Grimes Planning and Zoning Commission Agenda

**Grimes Planning & Zoning Commission Meeting November 5, 2024
In Person at Grimes Community Complex, 410 SE Main Street, Room 202 at
5:30 PM**

RE: DeCarlo Site Plan Amendment

RE: SE 4th & Main Street Site Plan

THE ALLURE ON 44
DIMENSION PLAN

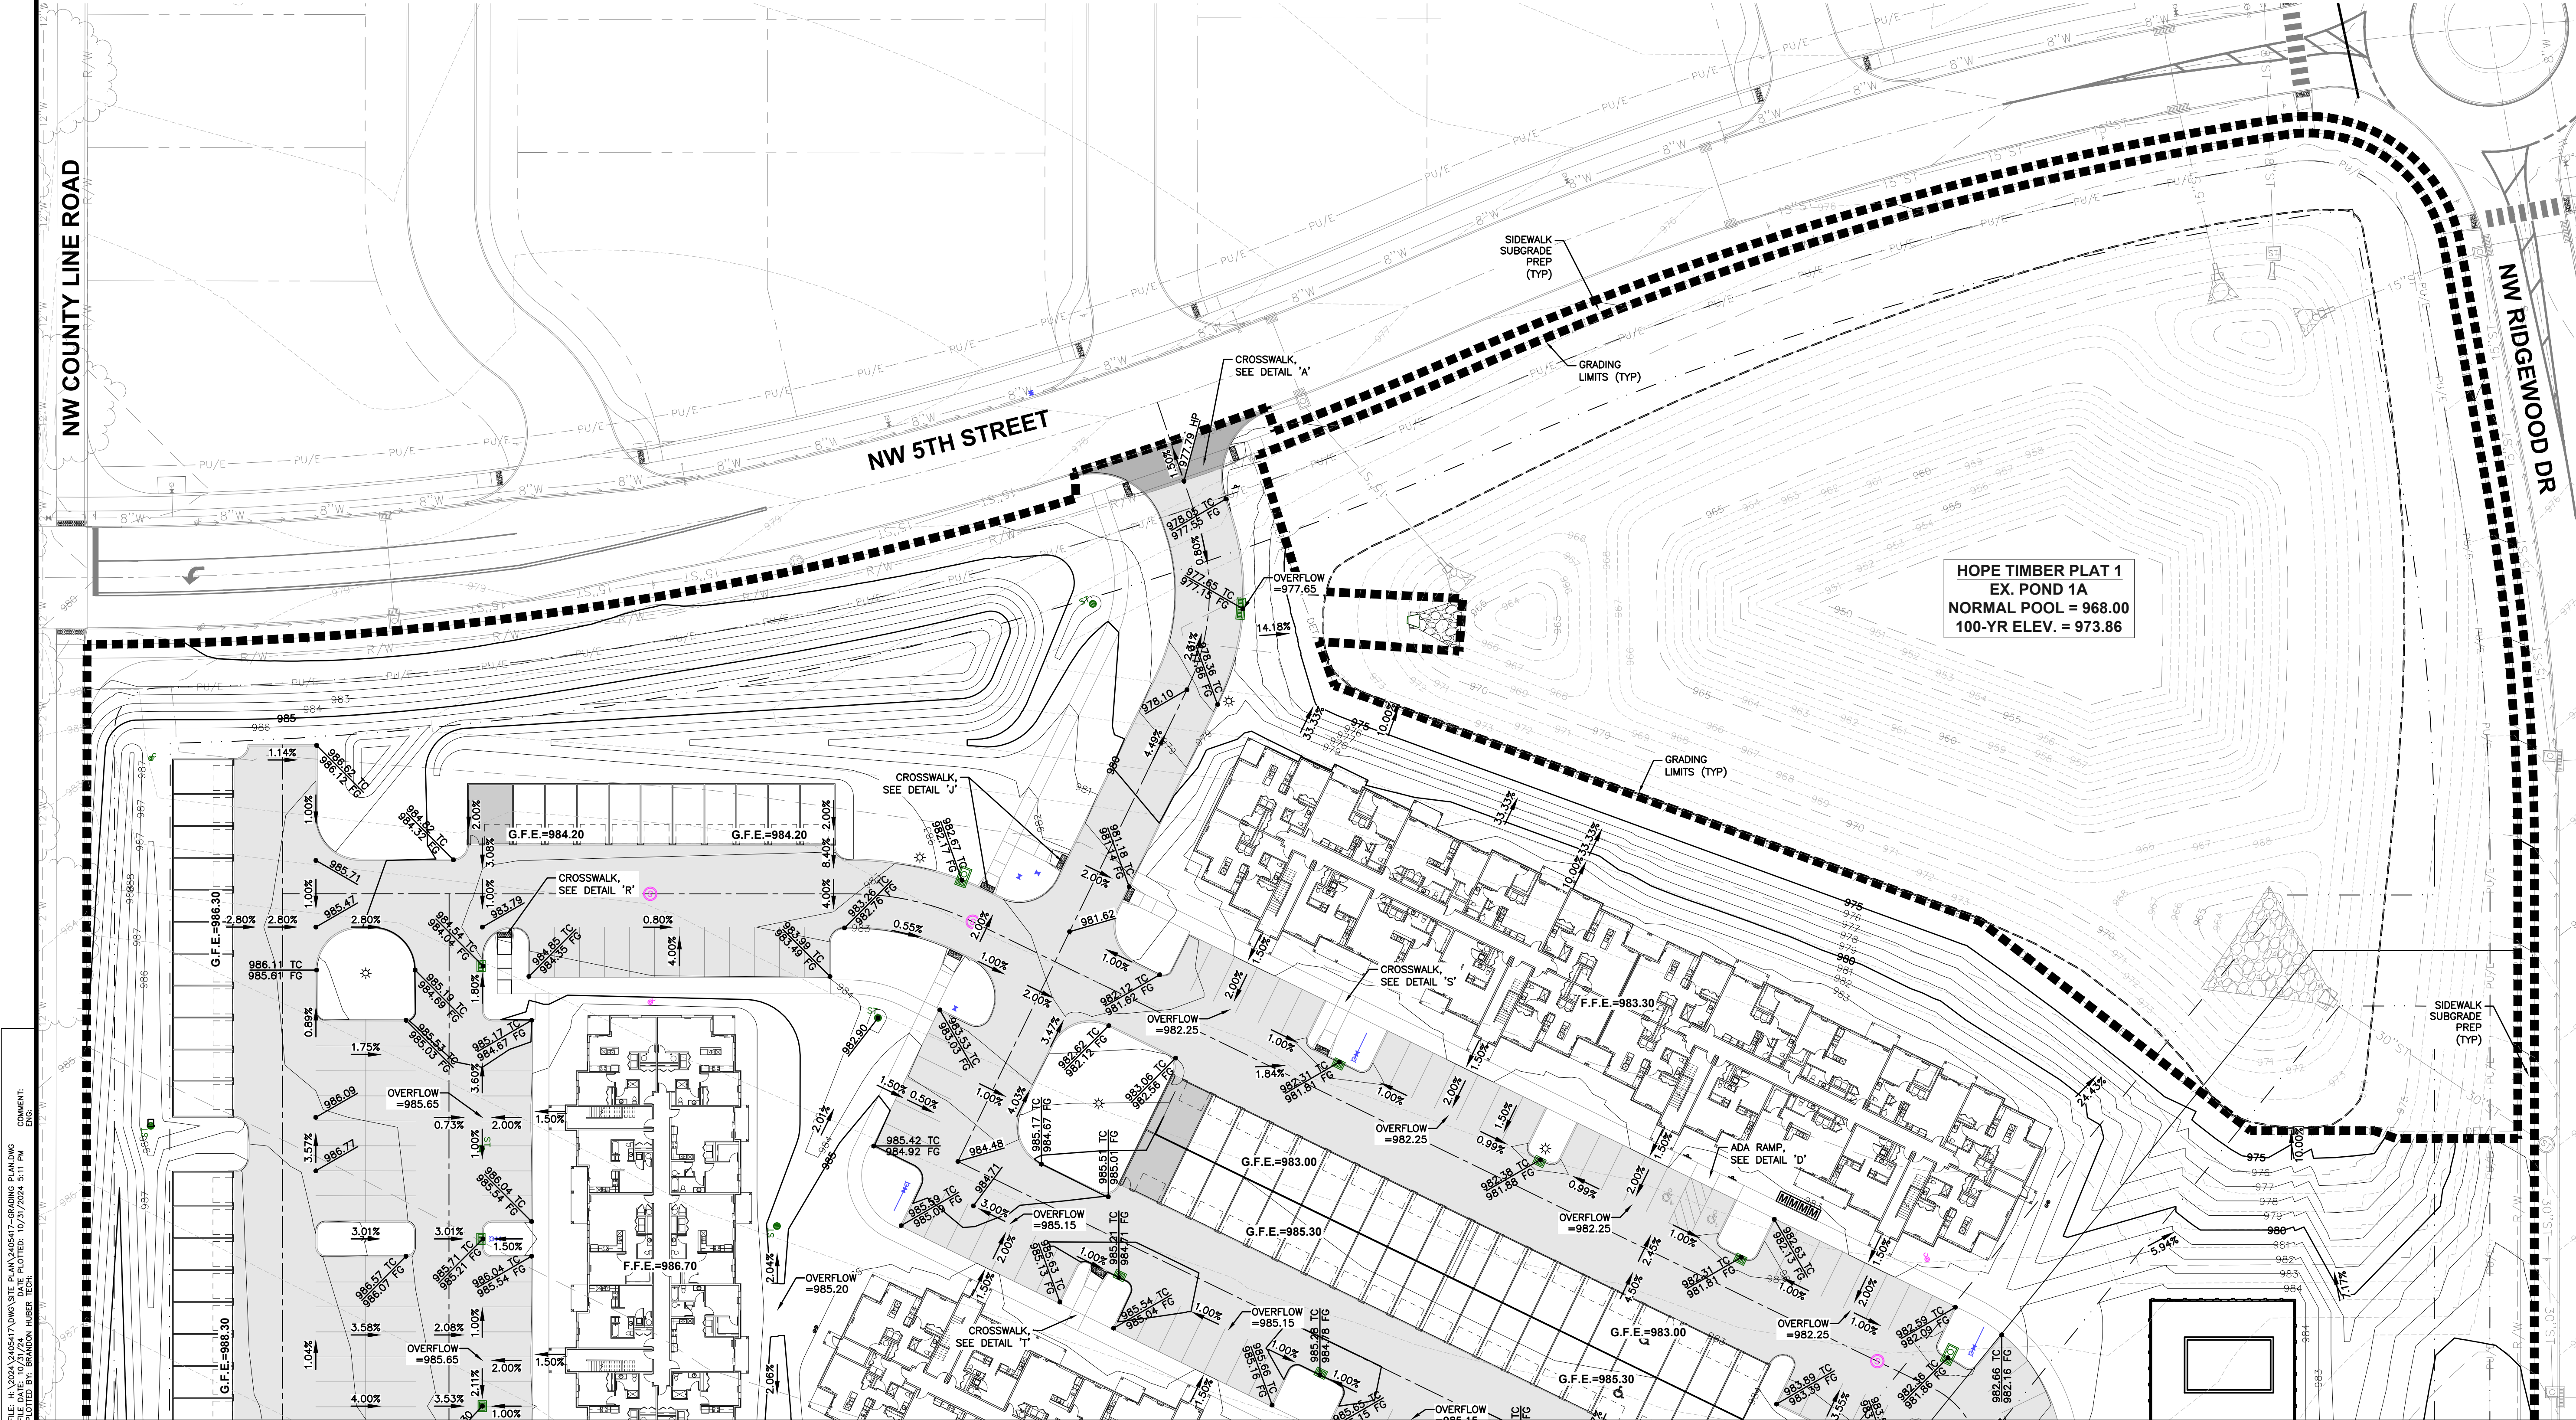
Sheet #C2 Dimension Plan Comments:
